**Basewide Remedial Investigation/Feasibility Study
Fort Ord, California**

Volume V - Feasibility Study

Appendix	RESPONSE TO AGENCY COMMENTS
----------	-----------------------------

1.4 Response to Agency Comments

PLATE: **25**

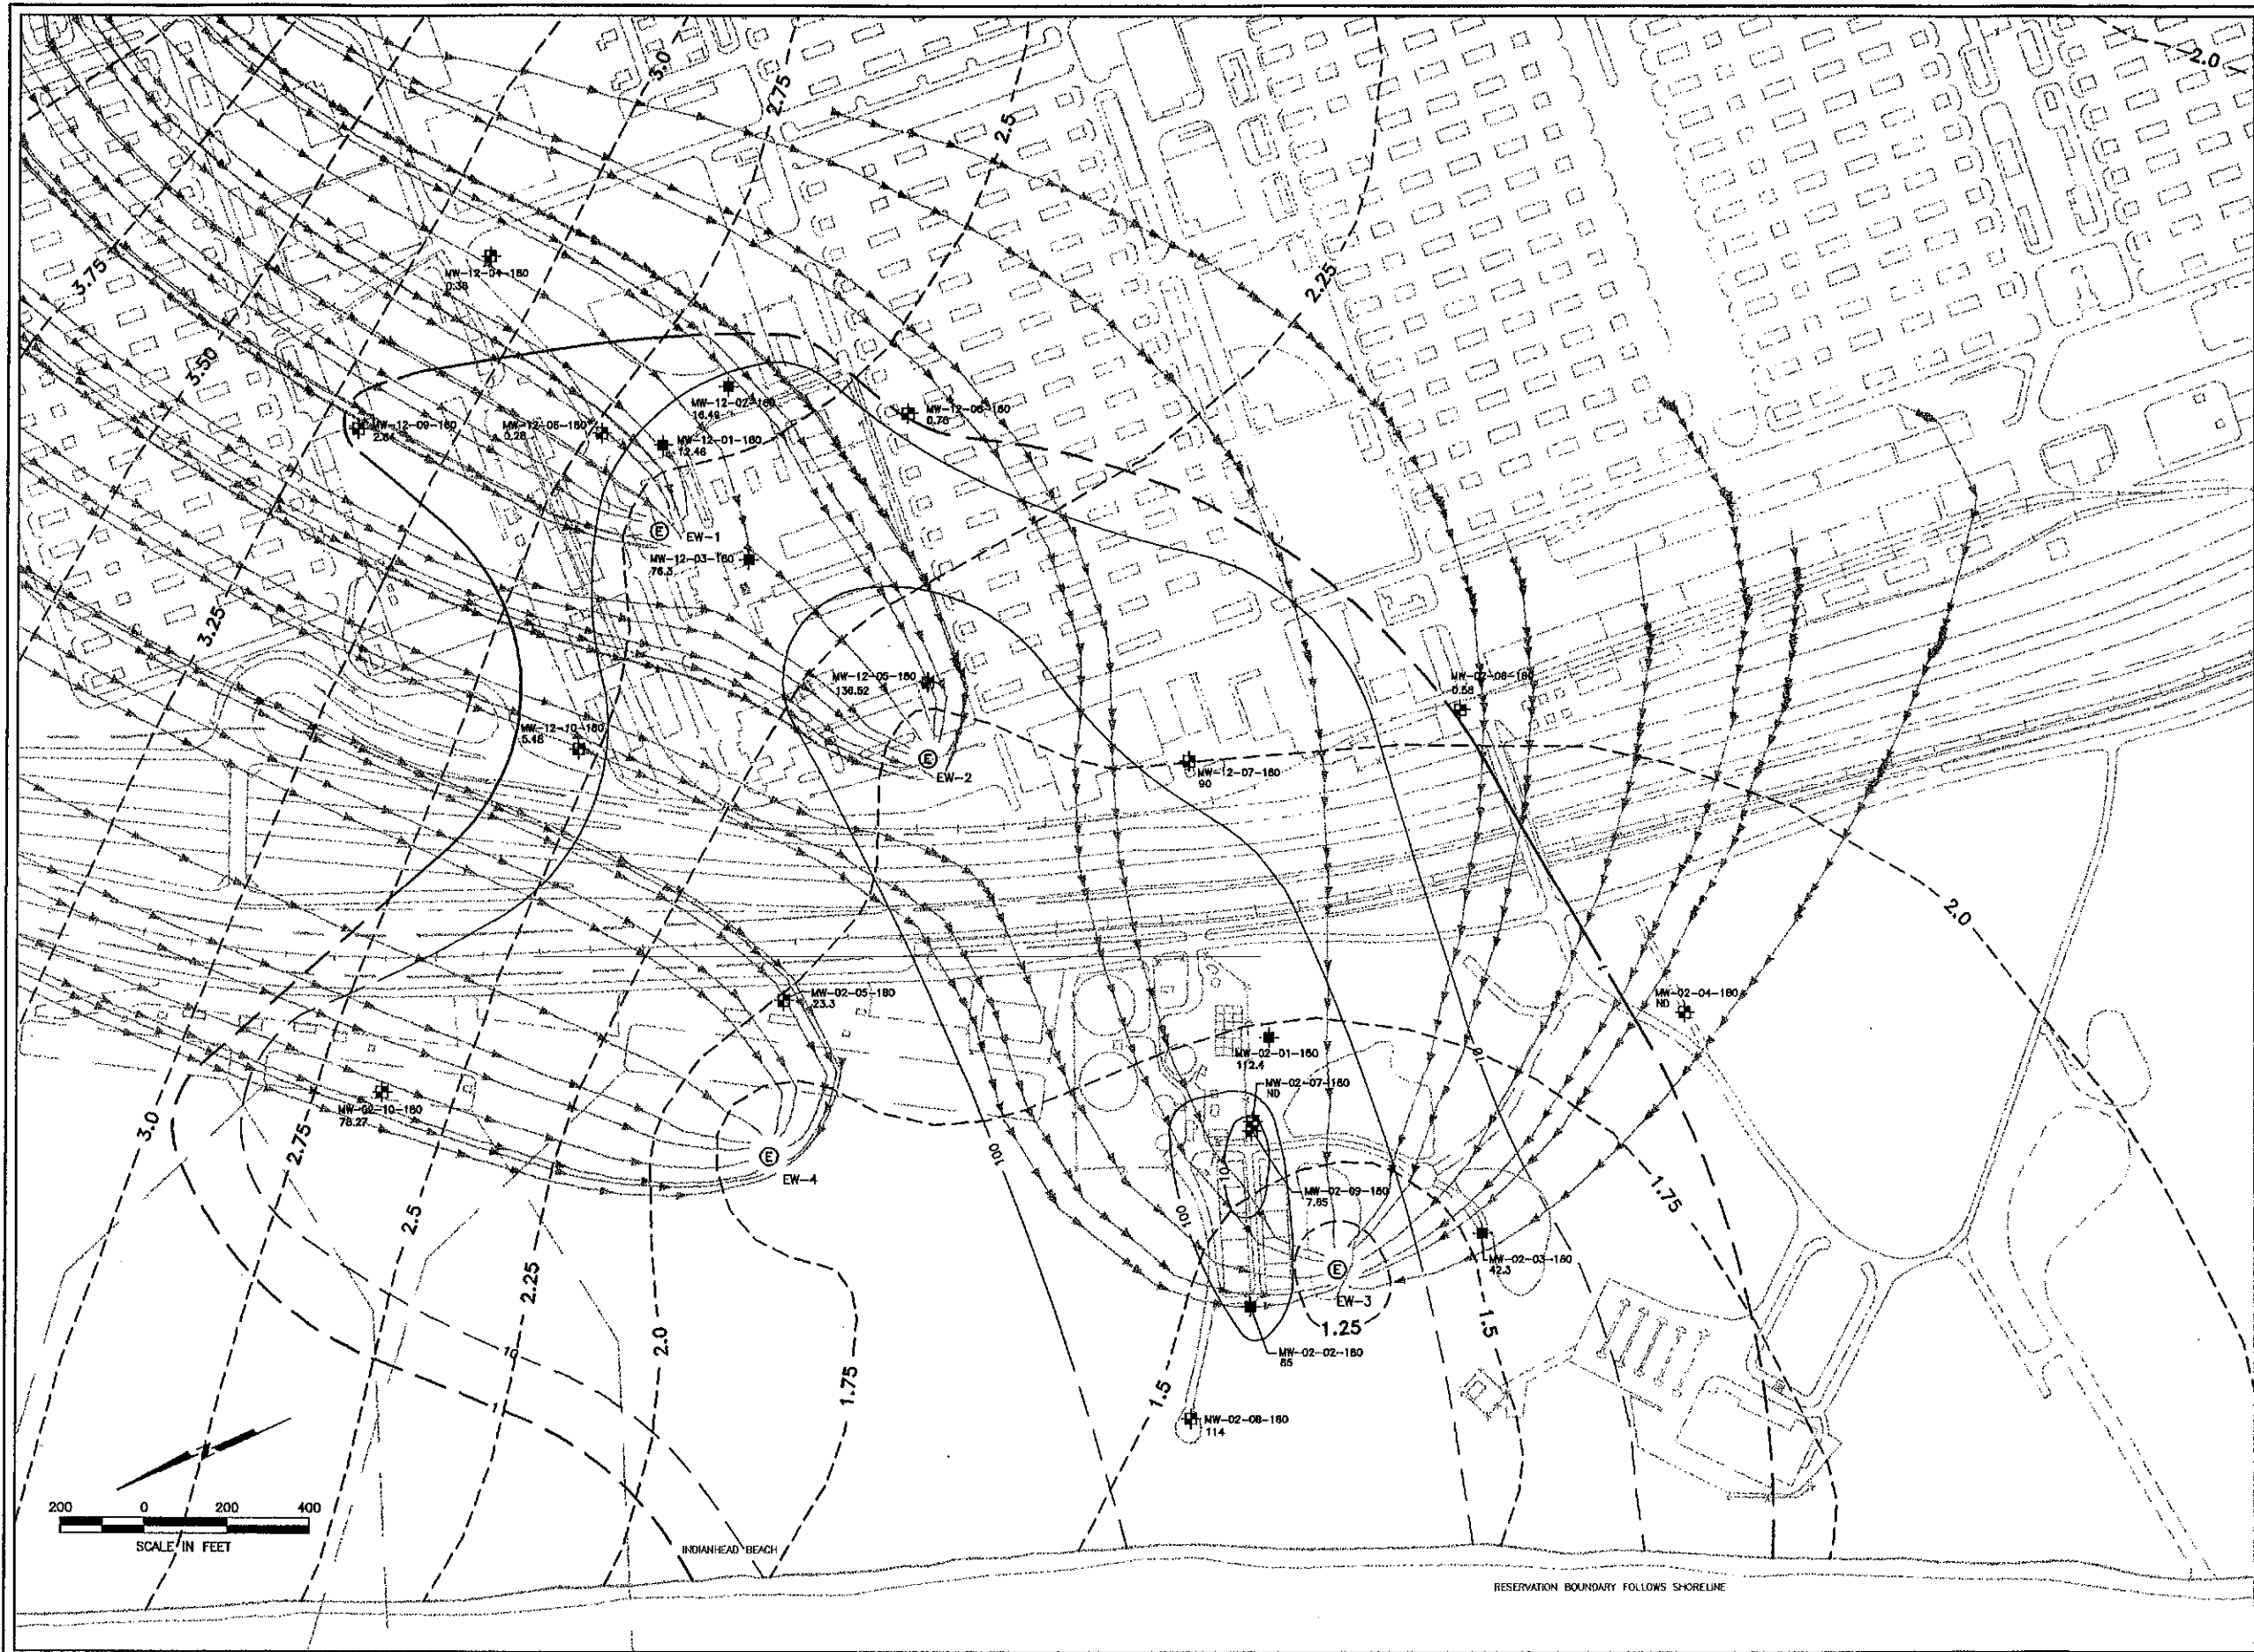
Comment 3: Plate 2.5: Map should be enlarged so that details of sampling locations can be determined.

Response: Plate 2.5 has been enlarged to better illustrate the details of sampling locations.
